ADDENDUM 2

ENVIRONMENTAL IMPACT STUDY (EIS)

ALTO MAIPO HYDROELECTRIC PROJECT

Figure 2
Intermediate Recharge Conceptual Model

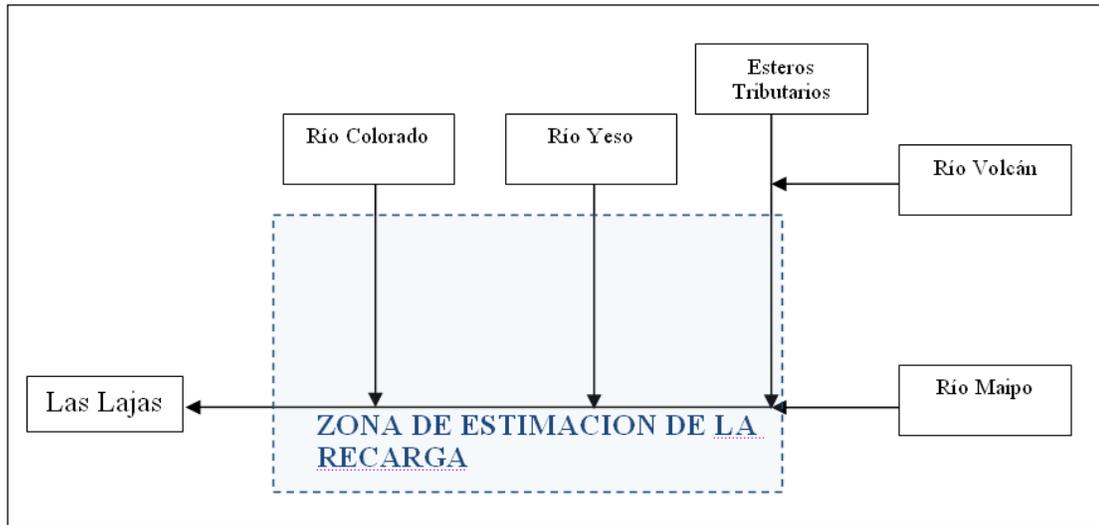
4. *The Water Balance Study (Conic BF 2008) submitted by the Project Owner analyzes the contributions and availability of intermediate basins in the determination of available recharges that, among other things, define the ecological flow rate and the flow rate at intake. In regard to the Balance, the Chilean Water Directorate (DGA) considers that in the case of the Colorado River, the intermediate contribution is overestimated because the discharges from the Alfalfal and Maitenes plants currently return the flow to the river and these returns are registered by the station at the mouth of the Colorado River (DGA station). When the project is in operation, which is the condition for which the contributing flows from intermediate basins must be calculated to estimate the available recharge, as these plants (Alfalfal and Maitenes) will not return their waters to the river. Therefore these flows must be subtracted from the balance and studied in the most unfavorable condition (low water level). The Project Owner is asked to conduct the analysis indicated and modify all later calculations as required, and attach this to the Addendum.*

To determine intermediate contributions under minimum monthly flow rates and low water flow rates with 85% exceedance probability, first the mean annual recharge was calculated in the project's area of influence, as shown in the model below:

According to the above figure, the mean annual recharge of the basin is estimated to be 27.1 m³/s, calculated as follows:

Graph 1
Discharge curve for the section: Colina Stream upstream of Volcán River confluence

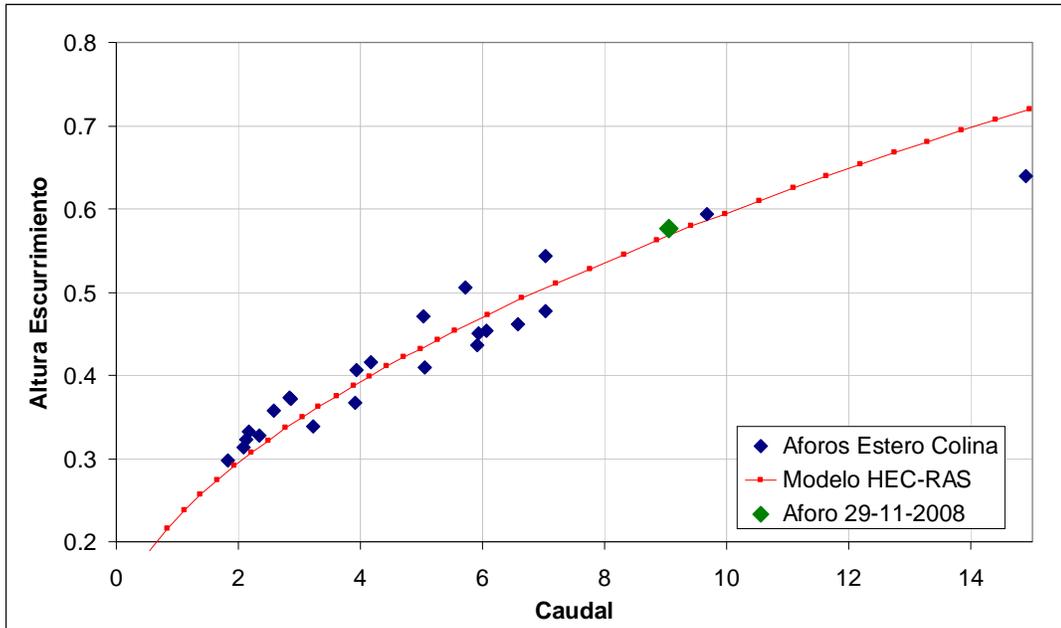
Response 10

The stated requirement to validate the discharge curve is accepted. As the basis of the correlation calculations used in the study of ecological flows in the tributary streams of the Volcán River (Annex 17, Addendum 1), the discharge curve used was constructed using the ratio of runoff depth to flow rate, measured in the gauging performed in 1990/1991 in the Colina Stream section before its confluence with the Volcán River.

In accordance with the above request, an additional point has been added to the abovementioned curve, which includes gauging performed on 29-11-2008, which confirms the trend, as shown in Graph 1. A photo of the section is also presented below along with the data sheet corresponding to the verification activity (see Photograph 1 and Table 6).

Graph 4

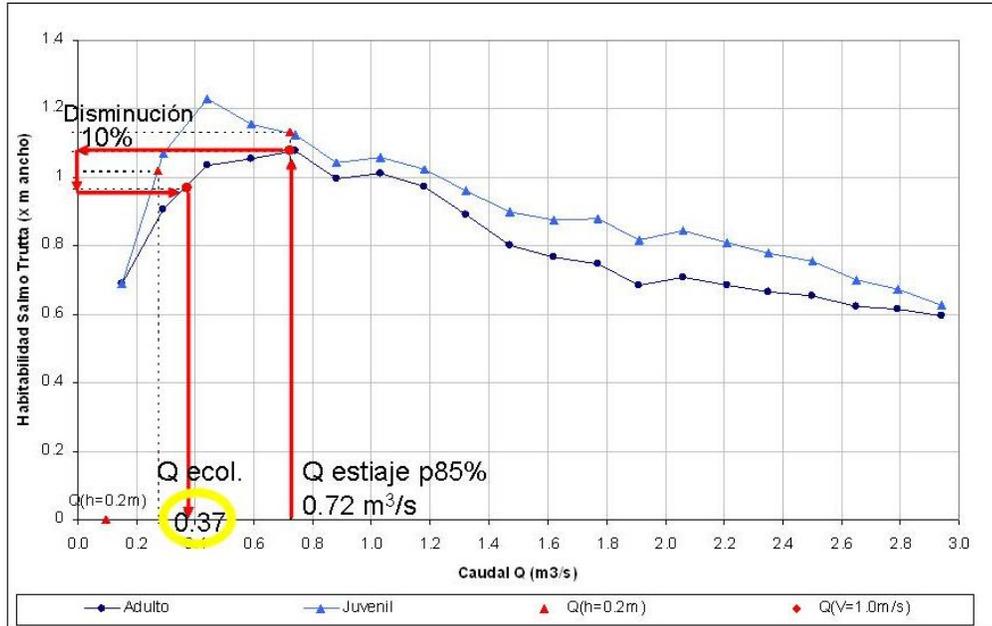
25. The Project Owner is asked to include a flowchart of the methodology presented in order to facilitate follow up of the variables involved and the final results, for the purpose of corroborating the conclusions presented in Figure D.2 and tables 6.2 and 6.7, among others. The observations made in the points above should also be taken into account.

As an example of the methodology, follow up on the calculations obtained for the outlet section of the Colina stream will be carried out in order to explain the D.1 sequence of figures and tables 6.3, 6.6 and 6.7 (see Graph 4 and tables 17, 18 and 19).

The Graph below (taken from Annex 17 of Addendum 1) illustrates the application of the methodology. A low water flow rate of 0.72 m³/s is taken and then a 10% habitat reduction is estimated to generate an ecological flow rate of 0.37 m³/s. The following tables show the follow up to this estimated value (yellow circle).

Figure 12
Reforestation area and site occupied by the inactive cururo warren
in the El Durazno sector

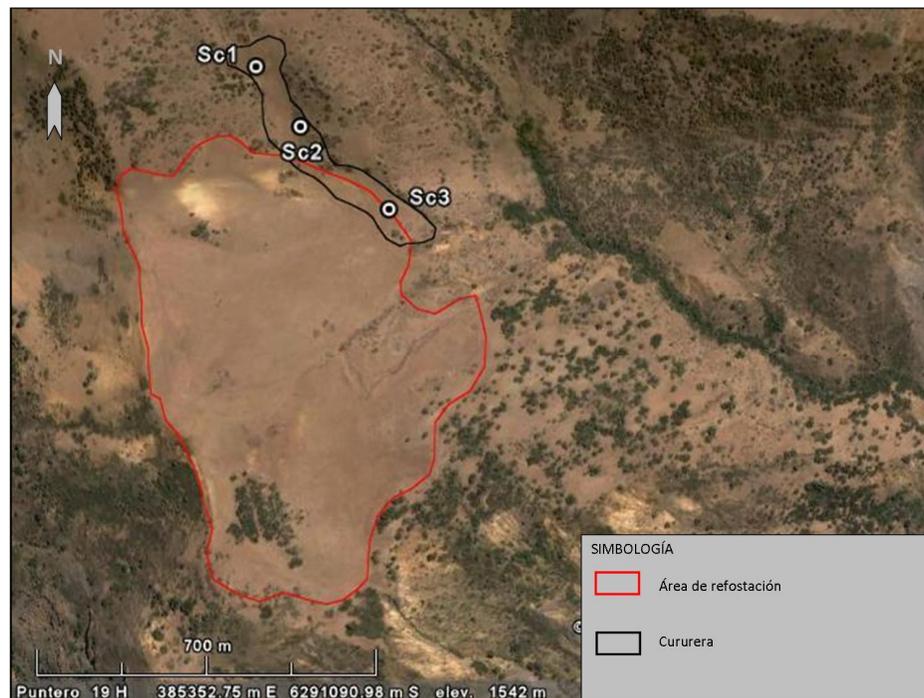
- 1. The plan to recover and relocate native fauna presented in the Addendum does not diagram the association between the project works and baseline in sectors that will be affected. For example, the plan proposes replanting with Frangel in the El Durazno sector without addressing the fact that this place contains an unusual feature, a colony of cururos (burrowing rodents) that will be affected by this compensation measure. The presence of these animals will impact the establishment of the plant species as well. This issue needs to be clarified and/or addressed.*

In the specific case of the El Durazno ravine, there is a “cururera” (cururo warren) in the area that is slated for replanting with Frangel. The warren is located on the northern edge of polygon slated for reforestation (Figure 12). This was confirmed in a field visit to El Durazno on December 30, 2008, at which time the area was inspected and no activity detected for this species (*Spalacopus cyanus*) (Photo 2). However, given that these animals occasionally abandon their warrens temporarily at certain times and then recolonize them, the Project Owner pledges to protect the site.

Therefore, to ensure that the reforestation activities do not affect the site of interest, the Project Owner will complement the planned environmental management measures as follows:

- The area occupied by the cururo warren will be excluded from the reforestation polygon and machines and workers will be prevented from entering the zone.
- Before reforestation begins, the warren will be inspected once again to verify its condition and asses the need for further action.
- Where further action is necessary, a buffer zone will also be established around the cururo warren to ensure it is not interfered with in any way.
